SUBJECT: Forwards response to RAI re TS change request to convert to improved standard TS for rev of overpressurization analysis.

H. B. ROBINSON STEAM ELECTRIC PLANT, UNIT NO. 2
DOCKET NO. 50-261/LICENSE NO. DPR-23
RESPONSE TO REQUEST FOR ADDITIONAL INFORMATION
AND TRANSMITTAL OF SUPPLEMENT 3 REGARDING THE
TECHNICAL SPECIFICATION CHANGE REQUEST TO CONVERT
TO THE IMPROVED STANDARD TECHNICAL SPECIFICATIONS

H. B. ROBINSON STEAM ELECTRIC PLANT, UNIT NO. 2
RESPONSE TO REQUEST FOR ADDITIONAL INFORMATION
REGARDING THE TECHNICAL SPECIFICATION CHANGE REQUEST TO CONVERT
TO THE IMPROVED STANDARD TECHNICAL SPECIFICATIONS
(NRC Letter Dated March 5, 1997)

**Figure 3.1 Pressure in Vessel Downcomer at the
Elevation of the Bottom of the Active Fuel (Limiting Case)**

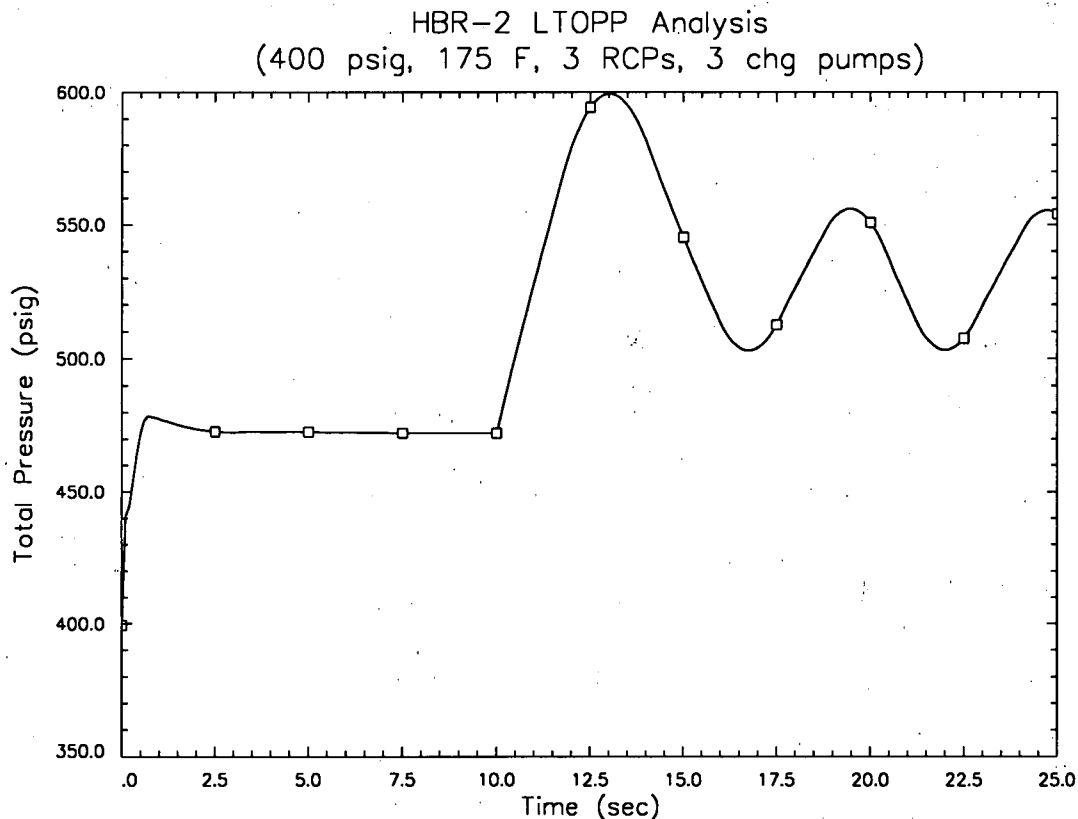
The results indicate that in all cases, there is sufficient margin to the pressure limit to allow one (1) SI pump to be capable of injecting into the RCS under the stated conditions. The maximum pressure was obtained in the case depicted in Figure 3.1, where the initial pressure was 400 psig and the initial temperature was 175°F.

The initial pressure in the downcomer is seen to quickly stabilize at approximately 470 psig. The indicated pressurizer pressure at this time was the desired 400 psig. The difference is due to both

the elevation head and the dynamic head from the RCPs and RHR pumps. The SI and charging flow injection began at 10.0 seconds, quickly raising pressure in the system until the PORV opened. The lift setpoint is 445.9 psig, but pressure continued to rise during the 0.6 second delay in opening the PORV and continued to rise until the mass flow rate through the PORV was greater than or equal to the mass flow rate into the RCS from the SI and charging pumps. The peak pressure reached in this case was 599.44 psig at 13.0 seconds, or 3.0 seconds after the transient initiation.
